Windsor Heights Planning and Zoning Commission

Consideration of Rezoning Application for Hy-Vee
Food Stores, Inc.

Hy-Vee Preliminary Site Plan Review

OVERALL SITE PLAN

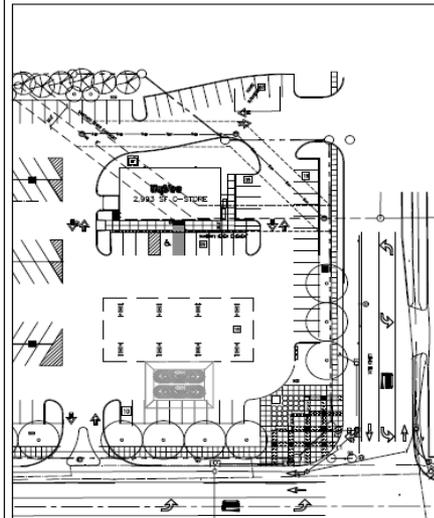
- Land Use
 - Subject property has been used as residential since before the adoption of the Zoning Code in 1997.
 - Hy-Vee may have been interested in the property at one time as the south portion of property was zoned UC.
- Layout
 - The applicant is proposing to utilize the subject property to create additional parking and access for a gas station and convenience store. The subject property will also be used as part of buffering requirements from the adjacent land use.
- Scale (setback- minimum requirements)
 - Front yard- 25 feet
 - Street side yard- 25 feet
 - Interior side yard- 0 feet
 - Rear yard- 10 feet

- Site Development
- Buffer
 - A 20 foot buffer would need to be provided along the north end of the subject property to separate adjacent land uses
- Design and landscaping
 - Any trees being removed will need to be replaced
 - Unenclosed parking facilities shall provide a minimum landscaped buffer of 10 feet along any street property line.
 - Staff has not yet received elevations- building should be compatible with the current Hy-Vee Food Store.

- Parking and internal circulation
 - 1 space per 200 square feet of building
 - Pre-development parking spaces = 363 stalls
 - Post-development parking spaces = 358 (includes parking under gas canopy)
 - Required- 357
 - Entrances and exits serving gasoline stations and convenience stores offering gas shall be at least 150 feet from a residential use, as measured along any public street.
 - The applicant has shown a right-in, right-out off of University Ave, specifically for the use of tank trucks- this has been accepted by the City Engineer as long as the traffic study does not come back negative.
 - The City is still waiting to received a Traffic Impact study which our City Engineer will be reviewing.

- Stormwater
 - The development is proposed to disturb less than 1 acre of land- since staff report was sent out, staff was informed they will be filling an NPDES with the state so they will be required to file a construction site erosion and sediment control application with the City.
 - The development must not inhibit development of other properties and should not increase the probability of erosion, flooding, or other run-off related events.
- Utilities
 - Sanitary sewer easement runs south through the Hy-Vee parking lot. Hy-Vee has shown an relocating route as shown in the updated site plan to run north and east of the building instead of through the building.
